FutureGen Response to Second Request
for Additional Information

Subject: Request for Additional Information #2 Regarding, FutureGen Applications for UIC Permit nos. IL-137-6A-0001, -0002, -0003 & -0004, November 14, 2013

U.S. Environmental Protection Agency Request for Additional Information #2, Regarding:
FG-RPT-017, Revision 1, SUPPORTING DOCUMENTATION: Underground Injection Control Class VI Injection Well Permit Applications
For FutureGen 2.0 Morgan County UIC Wells 1, 2, 3, and 4

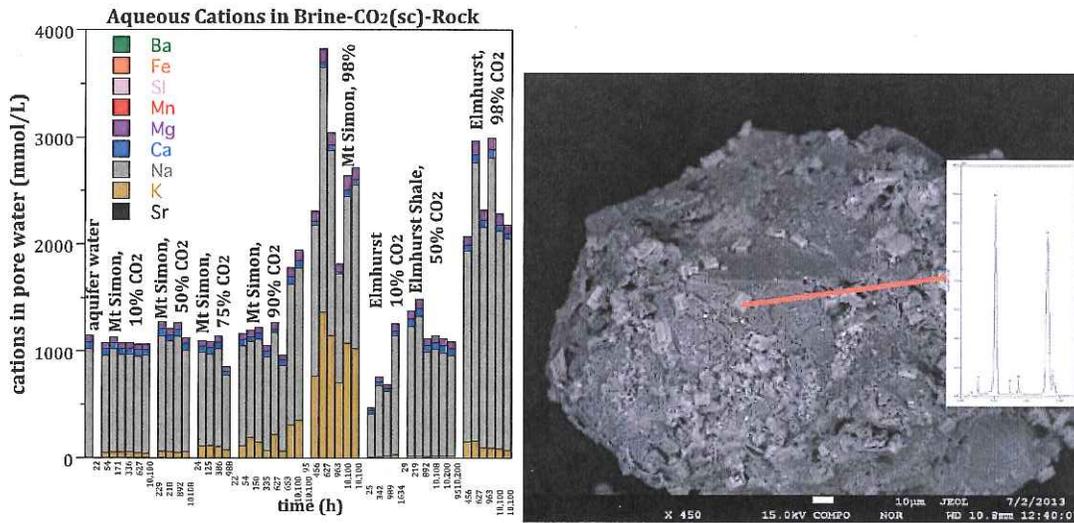
11-14-2013: Letter from Rebecca Harvey (EPA) to Kenneth K. Humphreys (Alliance), "Request for Additional Information Regarding four FutureGen 2.0 Wells, United States Environmental Protection Agency Underground Injection Control (UIC) Permit Applications for Four Geologic Sequestration Wells; United States Environmental Protection Agency UIC Permit Nos. IL-13A-0001, -0002, -0003, & -0004							
RAI #	Subject	Page	Doc. Sec.	Par.	EPA Comment/ Question/ Request	FutureGen Response	Footnote / Reference Citation
11-14-2013_001	Physical Processes Modeled	3.3	3.1.1.2		"Page 3.3 of the permit application states that laboratory investigations for quantifying the importance of chemical reactions are being conducted. Are any results available? Modeling considering reactive transport may need to be conducted if the lab results indicate significant iron carbonate precipitation that changes injection zone porosity."	Based on its experiments, the FutureGen Alliance (the Alliance) expects to see a small mass of precipitates (KCl, NaCl) forming near the injection well from the scCO_2 displacement of water, and does not expect to see the formation of any significant carbonate precipitates in this year (or years) time scale. Iron does precipitate, but concentrations are too low ($<0.6 \text{ mmol/L}$) relative to carbonate mass to be a precipitate issue. Simulations by others (White et al. 2005) of scCO_2 injection in a similar sandstone (also containing iron oxides) shows that over significantly longer time scales (1000+ years), aluminum silicate dissolution and aluminum silicate precipitation incorporating significant carbonate (dawsonite) is predicted, as well as precipitation of some calcite. That predicted mineral trapping did permanently sequester 21% of the carbonate mass, thus decreasing scCO_2 transport risk.	White, S.P., R. Allis, J. Moore, T. Chidsey, C. Morgan, W. Gwynn, and M. Adams. 2005. Simulation of reactive transport of injected CO_2 on the Colorado Plateau, Utah, USA. <i>Chemical Geology</i> 217:387-405.

Therefore, the Alliance expects to see a small mass of precipitates (KCl, NaCl) forming near the injection well from the scCO₂ displacement of water, and does not expect to see the formation of any significant carbonate precipitates in this year (or years) time scale. Iron does precipitate, but concentrations are too low (<0.6 mmol/L) relative to carbonate to be a precipitate issue. Modeling by others (White et al. 2005) in a similar sandstone (also containing iron oxides) shows that over significantly longer time scales (1,000+ years) significant aluminosilicate dissolution and aluminosilicate precipitation incorporating significant carbonate (dawsonite) is predicted, as well as some precipitation of calcite. That predicted mineral trapping did permanently sequester 21% of the carbonate mass, thus decreasing scCO₂ transport risk.

Figure 1. Slabbed core photos of the Lombard, illustrating the heterolithic nature of this interval.

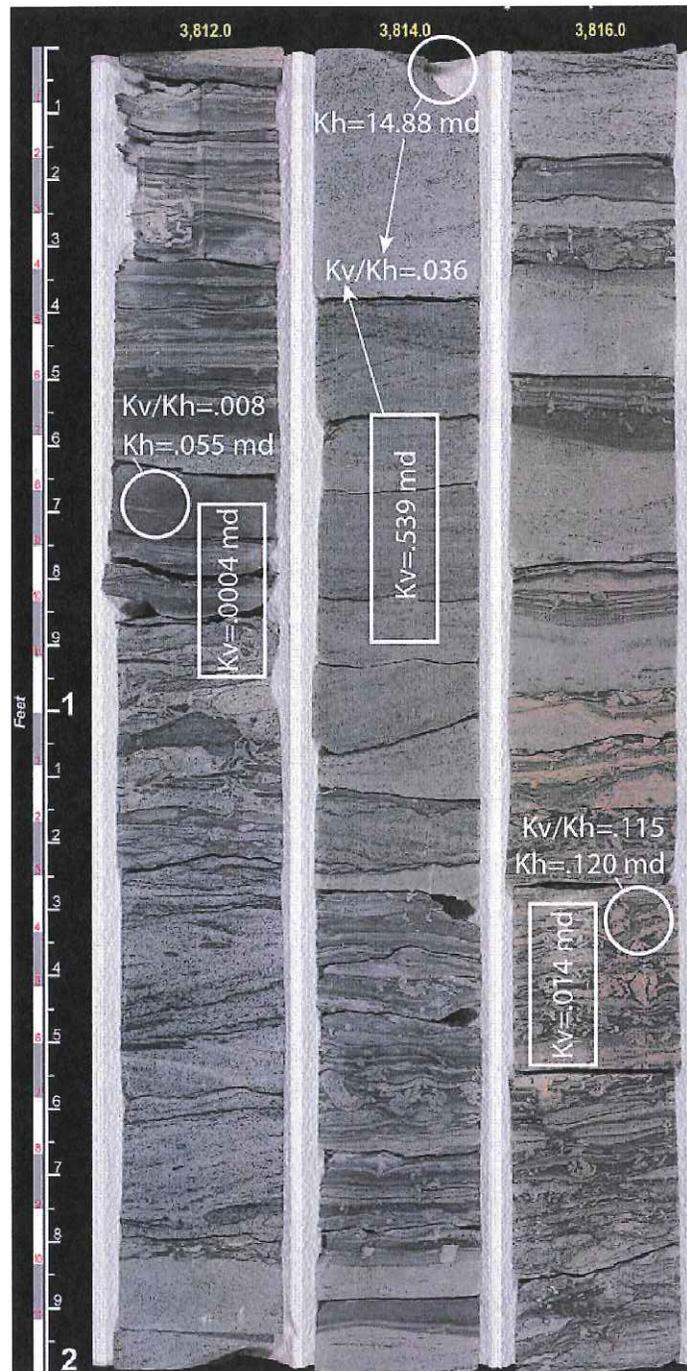
11-14-2013_004	Vertical Permeability		3.1.3.2	3	"Kv/Kh measured in 20 core plug pairs; highly related to presence of mudstone/shale; sparse data led to use of literature values. Given that 20 ratios were successfully determined, how do they compare to the literature values?"	No permeability-thickness product has been determined for the Elmhurst Formation. The permeabilities used for this formation were the ELAN-based permKcal values without applying a scaling factor.	
11-14-2013_005	Capillary Pressure and Saturation Functions		3.1.3.2	4	"Data was used from Manlove field to generate Brooks-Corey parameters for four different permeability ranges shown in Table 3.5. Please provide a citation for this information."	Table 3.4 of the UIC permit Supporting Documentation has been updated to show the Kv/Kh literature values for model layers that have measured values and the corresponding 20 measured Kv/Kh data points. The complete response to this request is discussed in Appendix B .	FutureGen Alliance. 2006. <i>Mattoon, Illinois Environmental Information Volume II Subsurface</i> . PNWD-3768, prepared for the FutureGen Alliance by Battelle - Pacific Northwest Division, Richland, Washington.

It should be noted that there is no available whole core from the confining layers; and available rotary sidewall cores do not provide sufficient sample size for vertical measurements of permeability. The Lombard is extremely heterolithic, as observed in the attached core photos (Figure 1), but the sparse individual sample pairs suggest that the literature value represents a very conservative value, and that vertical permeability is lower than modeled.

Figure 3.21. CO₂-Rich Phase Saturation for the Representative Case Scenario Simulations Shown at Selected Times (5, 10, 20, 70, and 100 years).

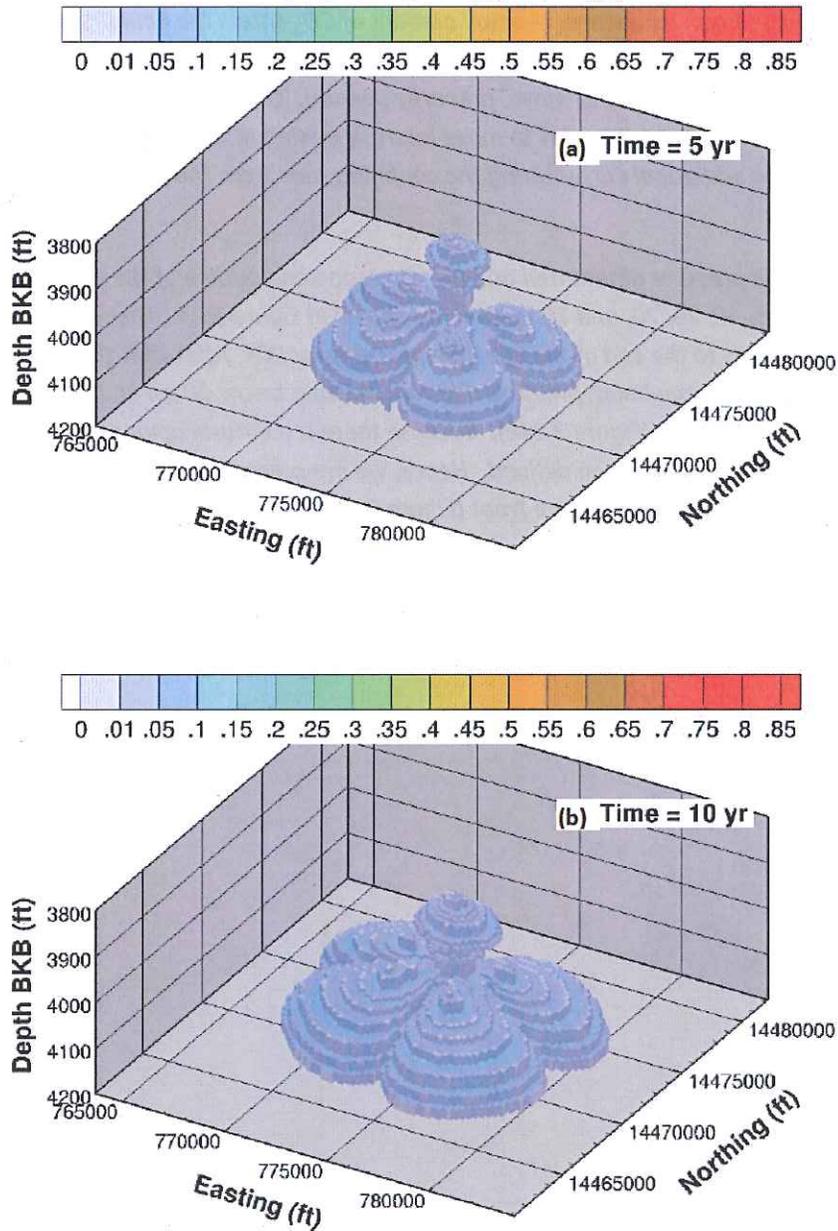
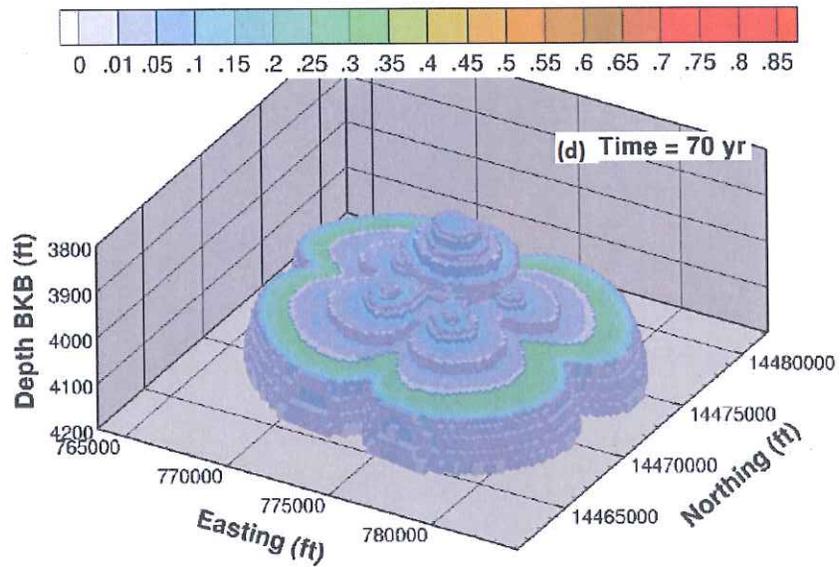
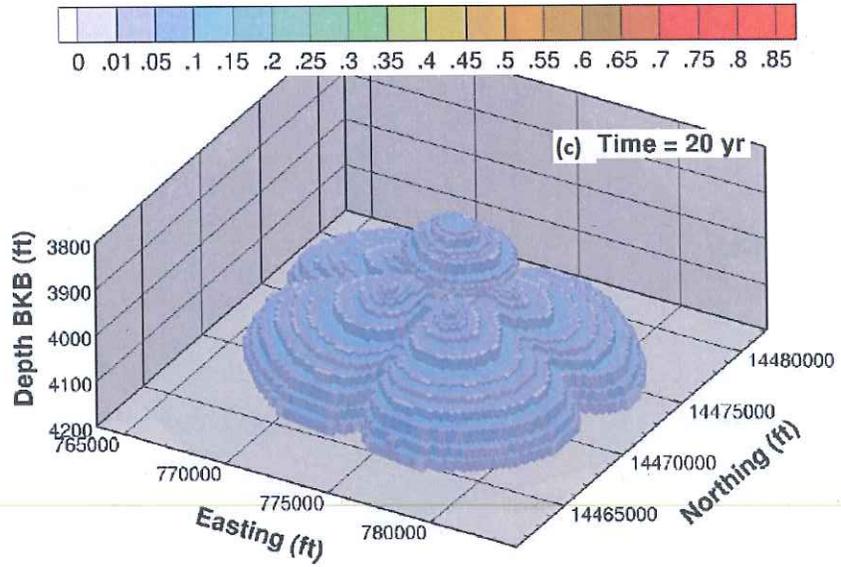
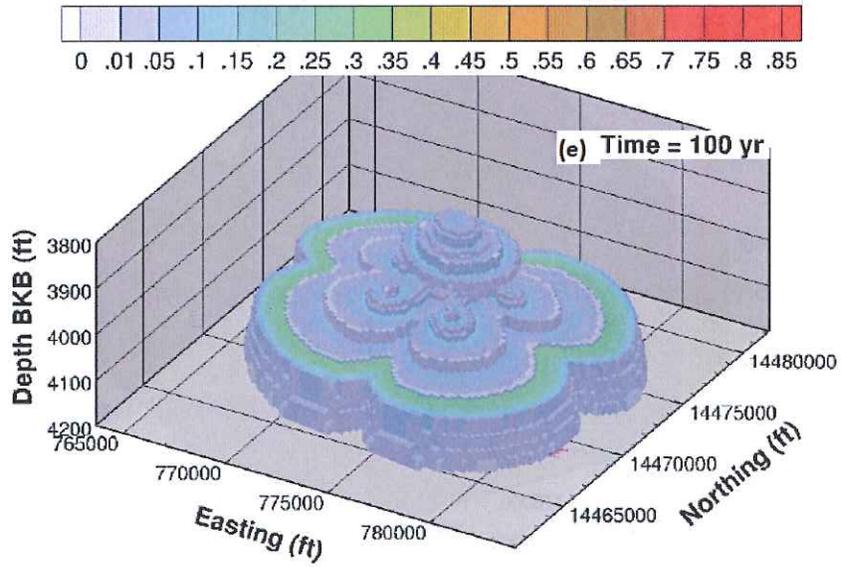
EPA Comment / Question / Request
 Section 3.1.5 of the permit application notes that the design of the injection wells was chosen to "avoid sensitive areas" (p. 3.26). What are these "sensitive areas" and how were they identified? Is this the reason the horizontal well legs are not evenly distributed in a radio fashion?
 "It would be helpful to have a verbal description of the changes between figures in a series: e.g., the 70yr figure in 3.2.1 has a wide area in green but the other three do not, what does this tell us? It is extremely difficult to judge scale from these figures. Please provide dimensions of plume and pressure front over time, together. A map view, such as Fig. 3.2.5, would be ideal. What is the largest extent of the plume and when does this occur? Because these figures are not at the same scale, they are hard to compare.
 "Please provide figures beyond year 70. We suggest figures to year 100."

The last paragraph and associated figures of Section 3.1.6 (Computational Model Results), beginning on page 3.29, were updated (as excerpted below) to describe the CO₂ migration processes. In addition, a plot corresponding to 100 years was added to each of the following figures: 3.21, 3.22, and 3.23. Furthermore, Figure 3.24 was replaced with plots showing the pressure differential and the CO₂ plume boundary at the same scale and in the horizontal plane (map view) for the same times. For convenience, the plots in each figure are marked with letters “a” through “e.” Please refer to the response to RAI# 11-14-2013_018 for information about the pressure front.

“Reservoir conditions are such that the CO₂ remains in the supercritical state throughout the domain and for the entire simulation period. The three-dimensional distribution of the CO₂-rich (or separate-) phase saturation is presented for selected times (i.e., 5, 10, 20, 70, and 100 years) in Figure 3.21. Additionally, and to better illustrate the CO₂ migration through time and space, a cross-sectional view of the CO₂ plume is presented as slices through the center of the injection wells and along the well traces (see Figure 3.18 for location of cross sections). Figure 3.22 and Figure 3.23 show the CO₂-rich (or separate) phase saturation for selected times for slices A-A’ and B-B’, respectively. Note that Figure 3.21 shows the plume in model coordinate space, while Figure 3.22 and Figure 3.23 show the distance from the center of the injection well pad. This is necessary because the well orientation is not aligned with the x and y axes of the model domain.

The cloverleaf pattern of the CO₂ plume that forms as a result of the four lateral-injection-well design can be seen in Figure 3.21a, which shows the plume after 5 years of continuous CO₂ injection. The central portion of the plume is a result of CO₂ injection into the Elmhurst in the vertical section of each well. Figures presenting the cross-sectional views show the location of the open interval relative to the plume and stratigraphic units. It can be seen in Figure 3.22 and Figure 3.23 that after 5 years of continuous CO₂ injection, the plume has spread both laterally and vertically, with some CO₂ migrating into the lower part of the Lombard. At 10 and 20 years, with more CO₂ being injected, the plume grows larger with time primarily in the lateral direction, but also vertically. Two years after the cessation of CO₂ injection (at 22 years), the plume reaches its maximum lateral extent (a comparison of the plume outline at different times in plan view is shown in Figure 5.1). However, the CO₂ within the plume continues to redistribute by migrating slowly upward due to buoyancy effects, with some of the CO₂ dissolving at the CO₂-brine interface at the edge of the plume. The vertical layering represented in the model is one of the controlling factors in the plume shape at later times. In general, the CO₂ tends to accumulate below a layer with a relatively higher gas entry pressure (and often lower permeability) than that of the layer directly below it. This area of relatively higher CO₂ saturation can be seen in Figure 3.21d and Figure 3.21e as the green “ledge” feature in the plume, and in Figure 3.22d, Figure 3.22e, Figure 3.23d, and Figure 3.23e as the flat-topped orange zone. Because the plume migrates primarily upward after injection ceases, the green feature becomes narrower with time (Figure 3.21d and Figure 3.21e). The vertical cross sections showing the plume at 100 years illustrate how the CO₂ distribution within the plume becomes more uniform with time (Figure 3.22e and Figure 3.23e). Because of the dissolution process, the CO₂ separate-phase plume area (in the horizontal plane) at 100 years is 2.2% smaller than the maximum area at 22 years.

Figure 1. Klinkenberg correction factor as a function of K-Klinkenberg for all analyzed FutureGen core plugs.

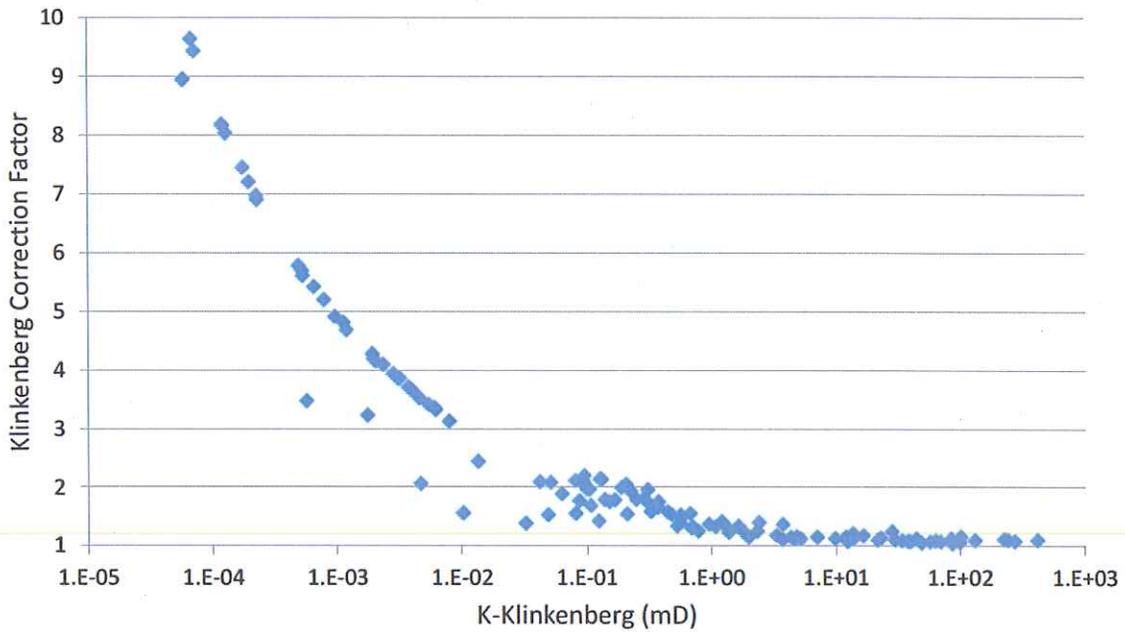
11-14-2013-015	Rocks Properties	2	"Horizontal intrinsic permeability of the confining zones" (see p. 3.7 of the permit application). Because of the reliability issues associated with ELAN log derived permeabilities below a certain limit (0.01 mD), FutureGen used the horizontal Klinkenberg permeabilities for each model layer. Was there any correction applied to the Klinkenberg permeabilities used for the confining zone layers, particularly because these may represent tight porous formations?"	Additional permeability corrections beyond the Klinkenberg correction were not applied. The Klinkenberg values were computed from K air values, measured by Core Laboratories using an unsteady state method, using the Klinkenberg Correction Factor (KCF). The KCF values were obtained for each sample using a standard procedure (Jones 1972). An extensive discussion is presented in Appendix E .	Jones, S.C. 1972. A rapid accurate unsteady-state Klinkenberg permeameter. <i>Society of Petroleum Engineers Journal</i> 383-397.

In Figure 1 (below), the computed KCF values are plotted against K-Klinkenberg for all analyzed samples. The plots show that for the tighter rocks (K-Klinkenberg < 0.01 mD), the KCF are always less than 10. Based on literature analyses (e.g., Civan 2010; Ziarani and Aguilera 2012), KCF values less than 10 indicate that the tighter samples are, in terms of the Knudsen flow regime, located in the lower end of the transition flow zone where $0.1 < Kn < 10$. To confirm this observation, Kn values are computed using Eq. D1 for λ and Eq 17 for r in Ziarani and Aguilera (2012) and plotted in Figure 2 vs. K-Klinkenberg. The plot shows that for the tighter cores, $Kn < 2$. For these Kn values, the Knudsen correction factor may be up to 10% to 20% larger than the KCF. However, given the inherent uncertainties of unsteady-state permeability measurements in the < 0.01 mD range (Rushing et al. 2004), the slightly larger correction factor would result in permeability values within the experiment measurement error.
